**Revised TENATIVE NOTICE OF FINAL  
FINDINGS, CONCLUSIONS AND DECISION  
OF THE CITY OF PORTLAND DESIGN COMMISSION  
ON AN  
APPEALED ADMINISTRATIVE DECISION  
(Type II Process)**

**CASE FILE: LU 16-286190 DZM – Williams and Cook Apartments**  
**LOCATION: 33 N Fargo Street**

**N. COOK ST. ELEVATION**  
 1705 5.31.2018 **EX.11**

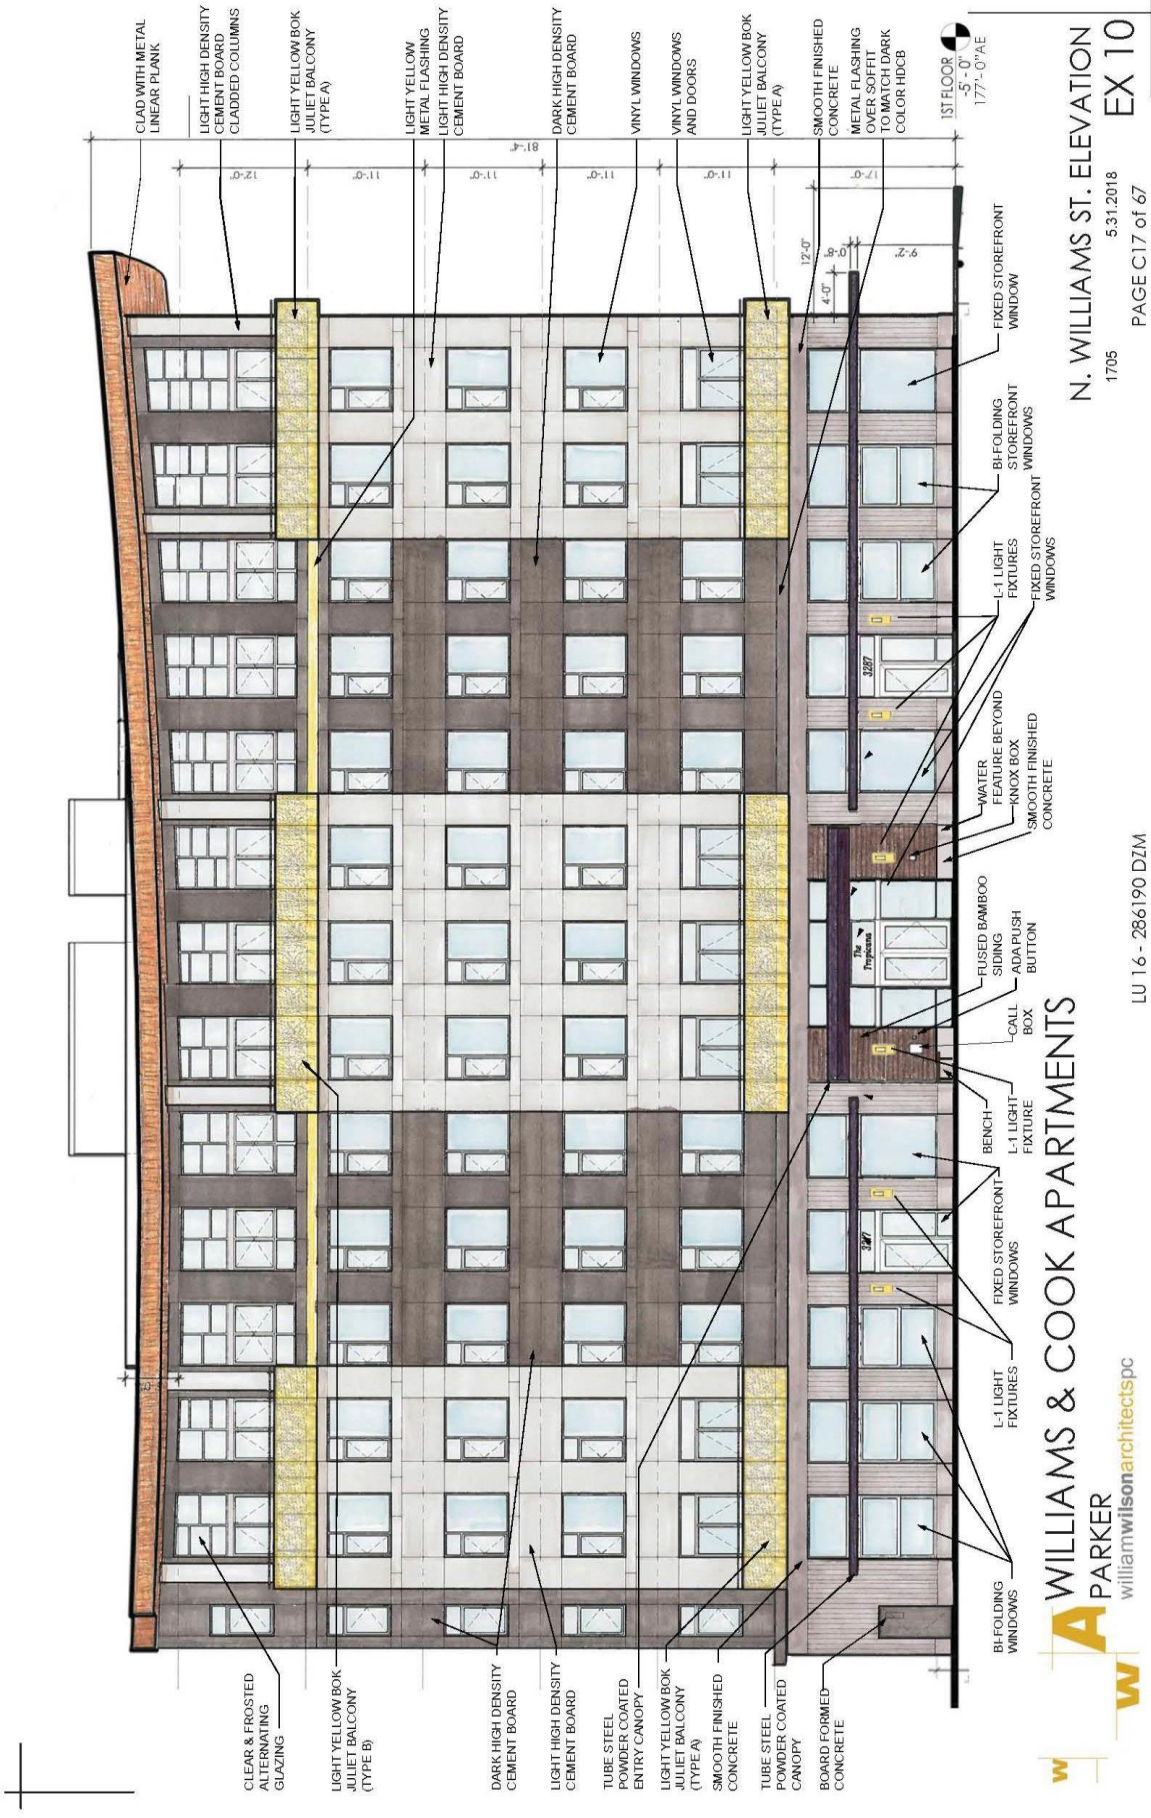
- Because the parking is only partially below-grade, it unduly impacted over 70% of the 137' long frontage of N. Cook. Although not clearly indicated on the plans or elevations, only the three 9'-wide storefront windows closest to the corner provided views into active uses on this frontage. The remaining frontage was programed with inactive uses - display windows cover the other 6 "storefront" windows, and the remaining frontage was taken up with an egress door, garage door and large louvers.

- Most of the N. Cook frontage was programed with inactive uses, creating a frontage with fewer "eyes on the street", and therefore less safe.
- No lighting plan was provided, however, exterior lighting in addition to the sconces at the entries would add further illumination and increase safety along the sidewalk areas adjacent to the building.

Additionally, the applicant has agreed to work with RACC to install a Public Art Piece reflecting the history of the site and local area on the blank wall facing N. Cook (Exhibit H.43), providing an important link to the plan area's history and traditions.

Since the original Decision, a revised design and further information has been submitted to better illustrate how this guideline is met. Additionally, as noted above under P1, a Public Art Piece reflecting the history of the site and local area will be located on the blank wall facing N. Cook (Exhibit H.43), minimizing the negative impact of locating the loading space immediately adjacent to the sidewalk.
